MIDWEST POOLED FUND PROGRAM

Progress Report - Fourth Quarter 2010

Midwest Roadside Safety Facility
Nebraska Transportation Center
University of Nebraska-Lincoln

Figure 16. Transition Cap for 32" PCB to the Wisconsin 56" Single Slope Median Barrier

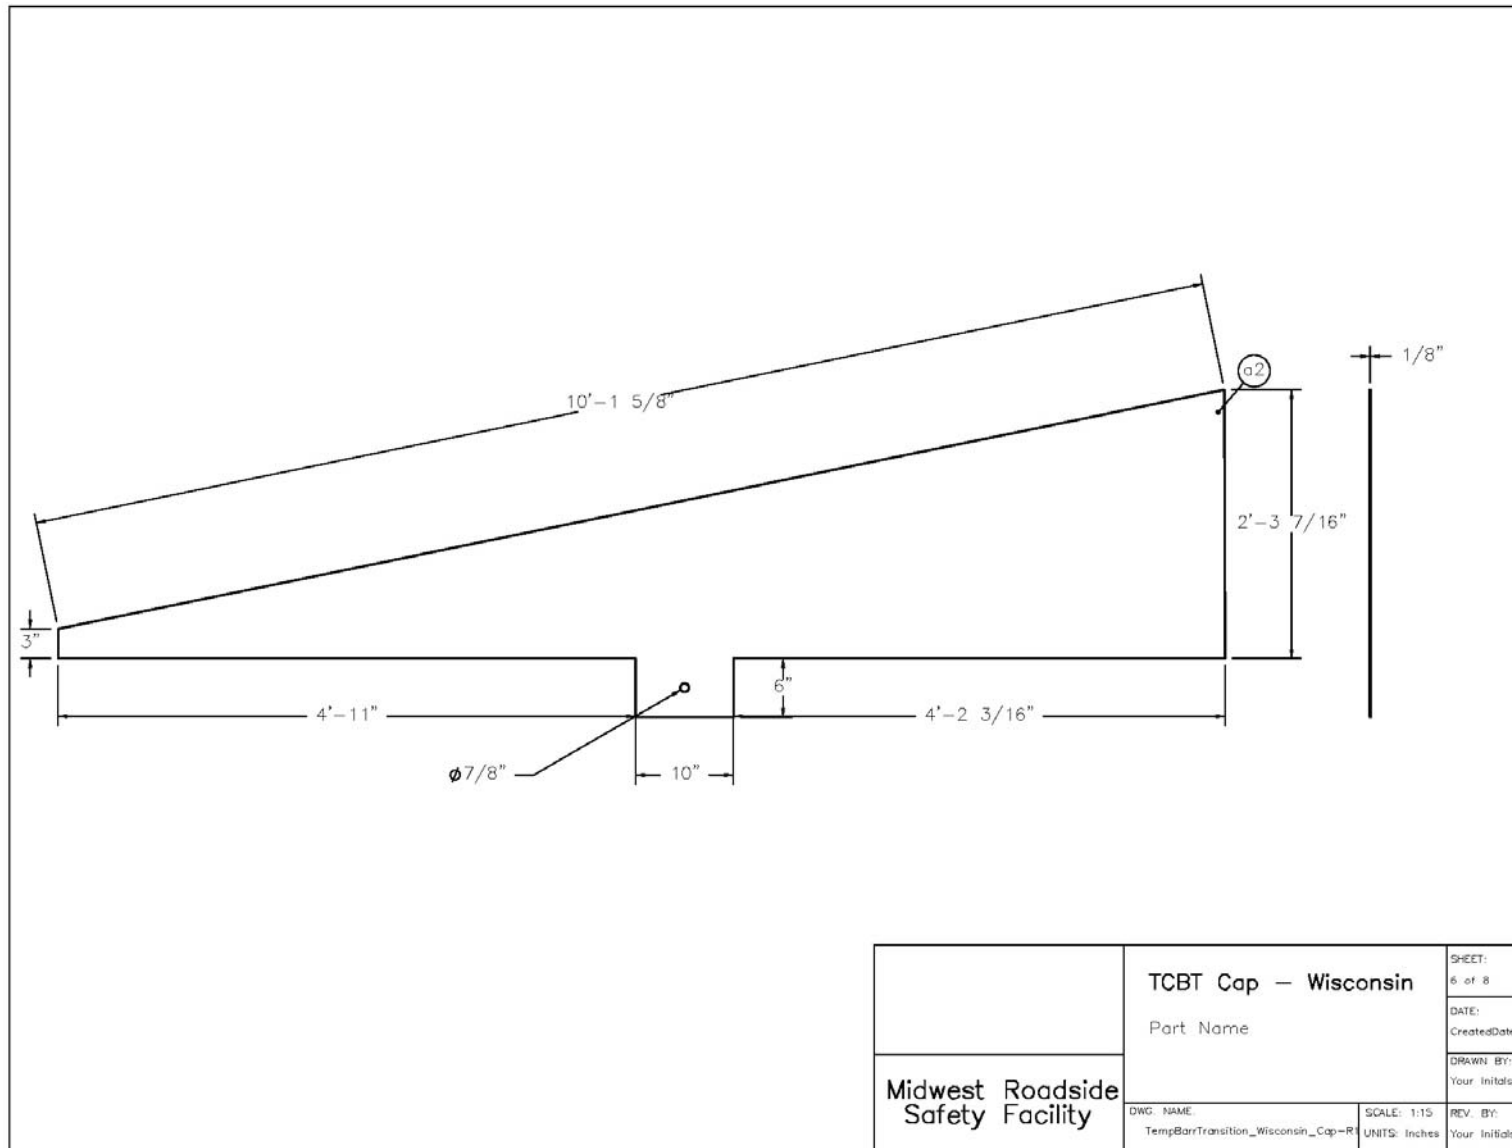
I also looked into your questions regarding the overhanging piece of steel on the TCB median barrier approach transition cap. On the tested system, we designed the cap to match the slope of the sides of the PCB section. Because the tops of the PCB section and the median barrier were not aligned, the cap had an overhanging piece of steel on the oncoming traffic side. This piece is not required for cap designs that match up to barriers of different widths or heights. Changes in the height of the median barrier will require a different cap design. We would require the following.

1. All cap designs use the same vertical slope for the cap as the tested design.
2. The sides of the cap should match the side slope of the F-shape PCB segment.
3. If the cap is longer than the tested cap design, intermediate anchorage should be provided on the side of the cap at the midspan length to provide additional anchorage.

I have attached details for a representative cap for a transition from 32" PCB to the Wisconsin 56" single slope.
